MDDP AMENDMENT & FINAL DRAINAGE REPORT

MERIDIAN ROAD & BENT GRASS MEADOWS DRIVE

DATE:
March 2020
Revised: July 2020

Engineering Review

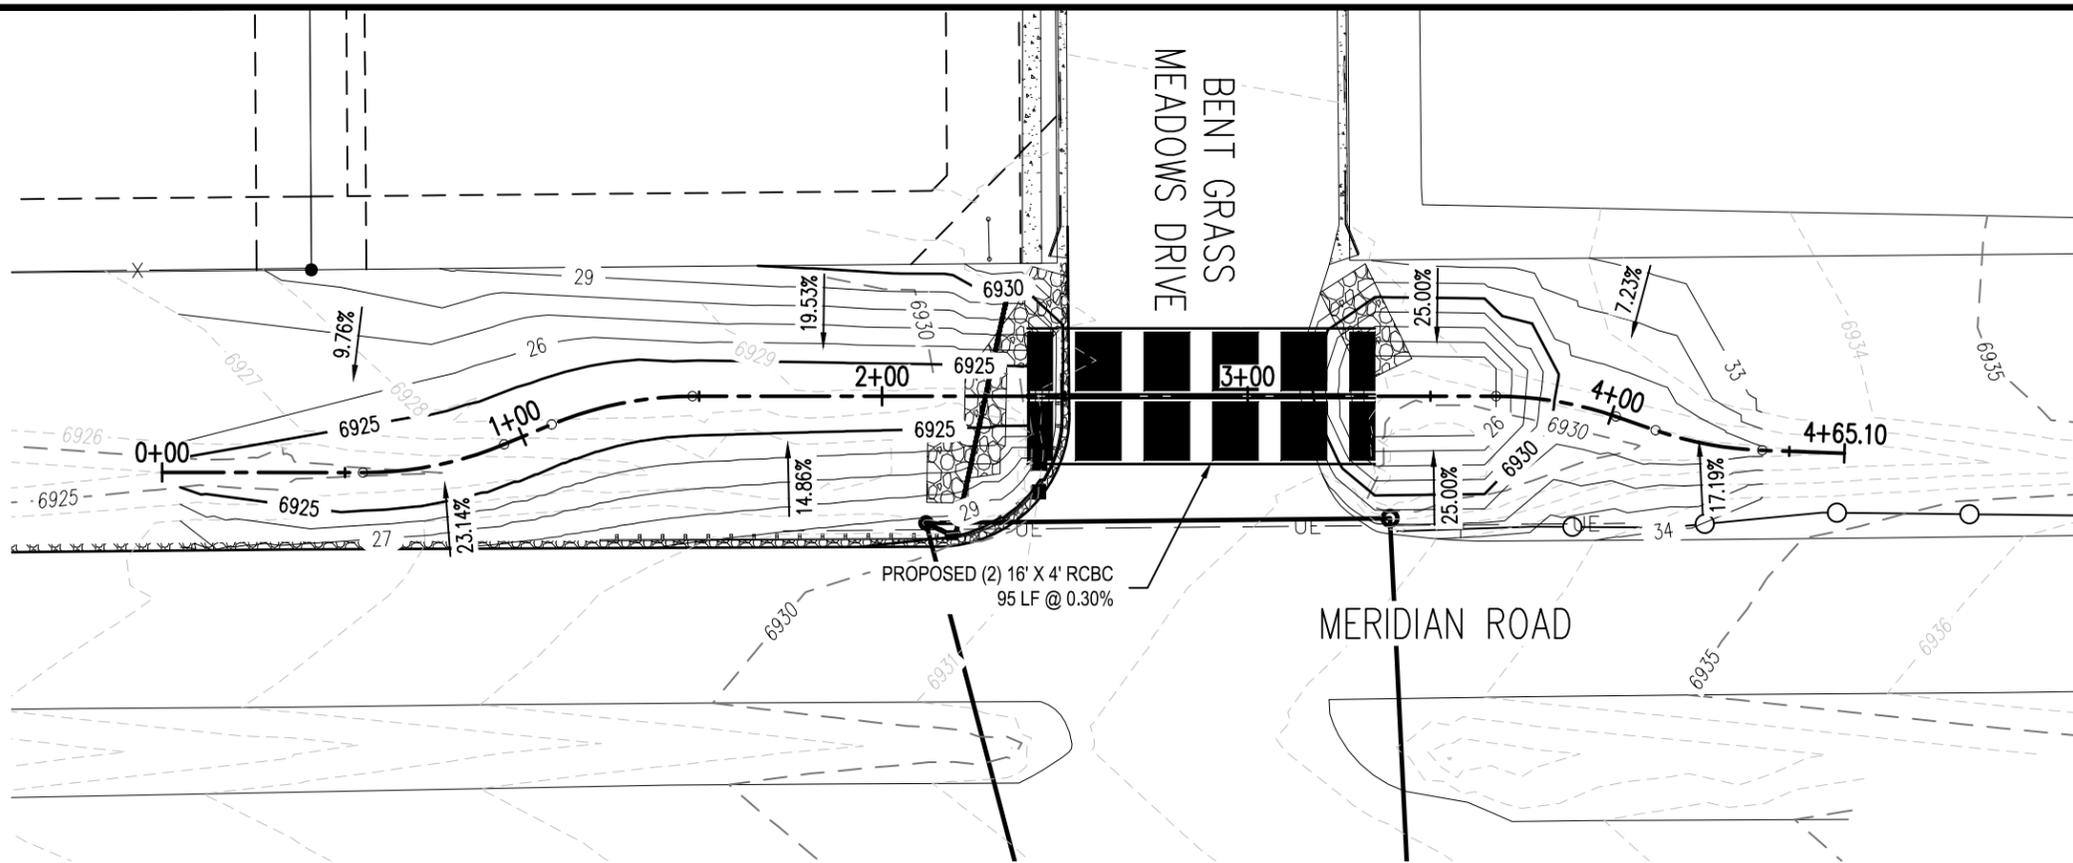
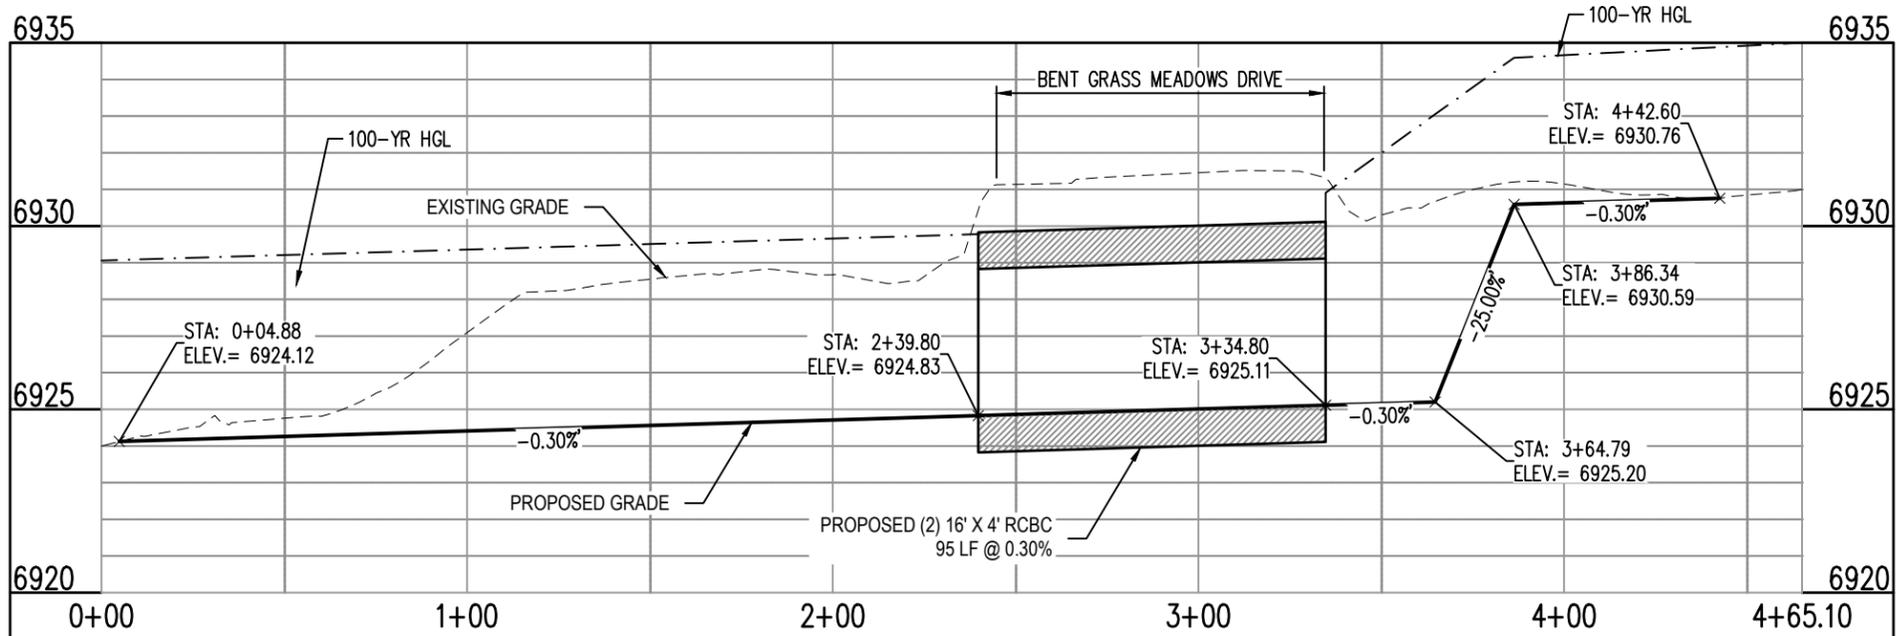
Replace Figure 3-13 (with prev. redlines) and add 3-12 if desired
